## **Adopted amendments to ECE/TRANS/WP.29/GRSG/2011/11 - Proposal for amendments to Regulation No. 118 (Burning behaviour of materials)**

The changes to ECE/TRANS/WP.29/GRSG/2011/11 are shown in red characters.

**Example 2**

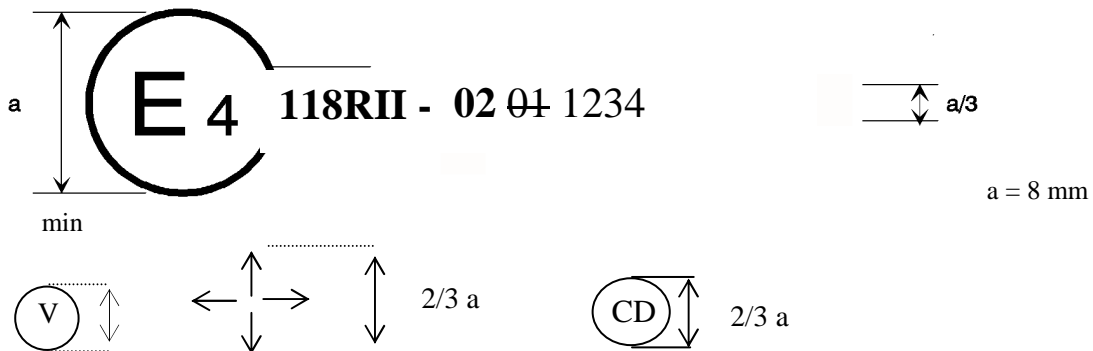
The above approval mark affixed to a component shows that the type concerned was approved in the Netherlands (E4) pursuant to Part II of Regulation No. 118 under approval number 01 021234. The first two digits (01 02) of the approval number indicate that the approval was granted in accordance with the requirements of the 01 02 series of amendments to Regulation No. 118.

The additional symbol  indicates that this type of component the direction which the component may be installed has been approved according to its horizontal and vertical burning rate.

The symbol  indicates that the component fulfils the requirements in paragraph 6.2.2.

The symbol  indicates an approval as a complete device such as seats, separation walls, etc..

The additional symbols are only used if applicable."

Figure 1

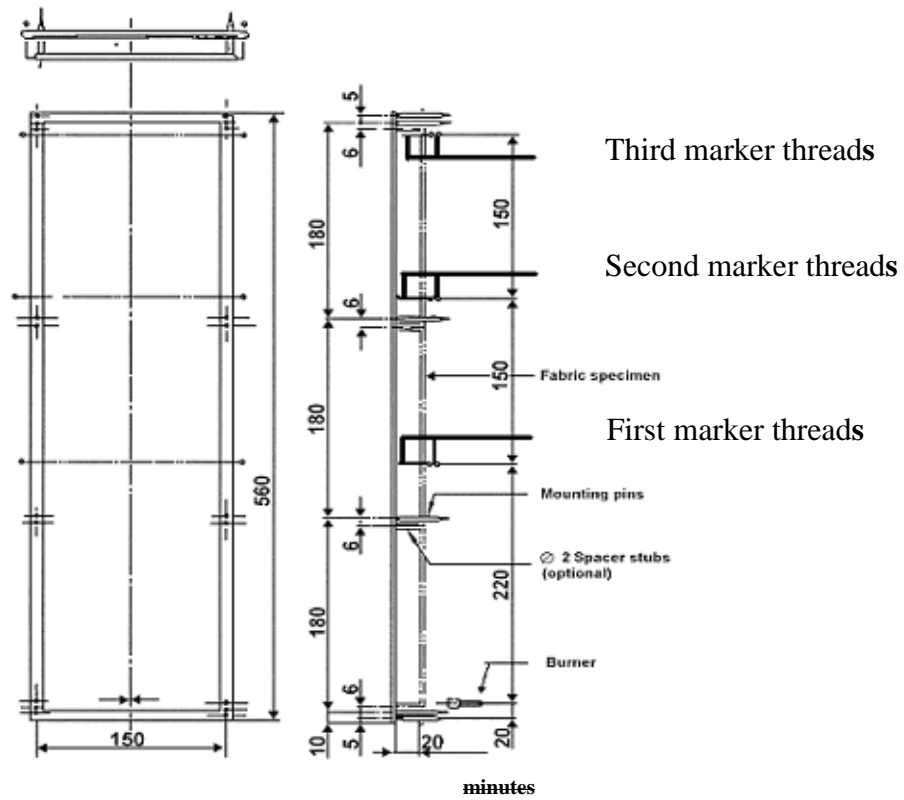
Annex 8, figure 1, amend to read:

**Specimen holder (Dimensions in millimetres)**

Figure 2

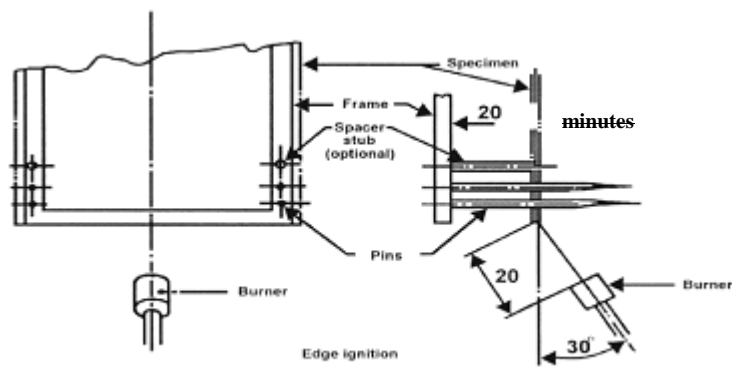
Annex 8, figure 2, amend to read:

**Burner ignition location (Dimensions in millimetres)**
